SUNDRY NOTICES AND REPORTS ON WELLS
Do not use this form for proposals to drill or to re-enter an abandoned well. Use form 3160-3 (APD) for such proposals.

Mewbourne Oil Company requests approval to make the following changes to the approved APD:

DRILLING CONDITIONS OF APPROVAL

OPERATOR'S NAME:	Mewbourne Oil Company
LEASE NO.:	NMLC0070397
WELL NAME & NO.:	Hereford 20/20 W1OB Fed Com #1H
SURFACE HOLE FOOTAGE:	205'/S & 1330'/E
BOTTOM HOLE FOOTAGE:	100'/N & 1980'/E
LOCATION:	Section 29, T.19 S., R.35 E., NMPM
COUNTY:	Lea County, New Mexico

WELL LOCATION AND ACREAGE DEDICATION PLAT

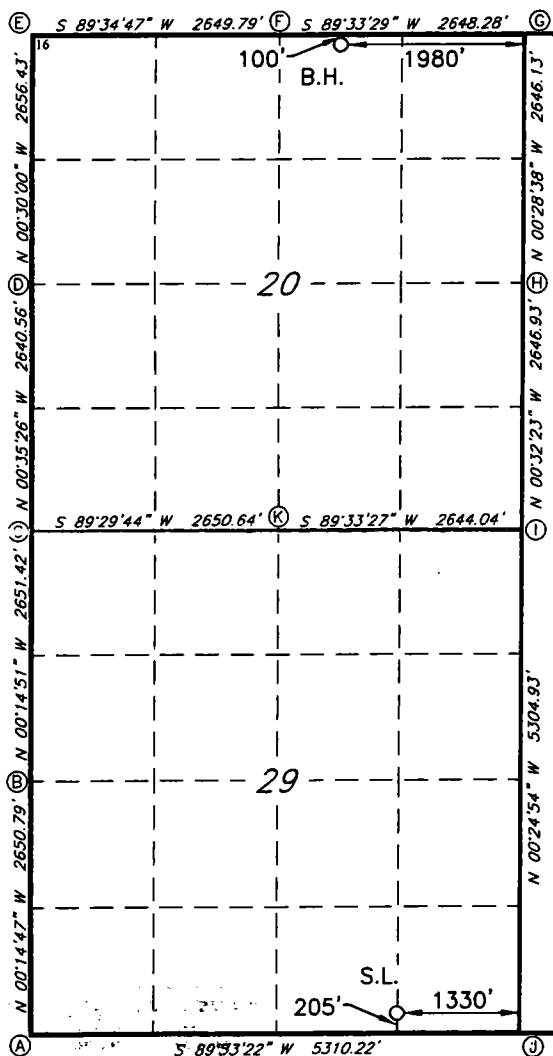
1/22/19 NAME, S.L. & B.H CHANGE
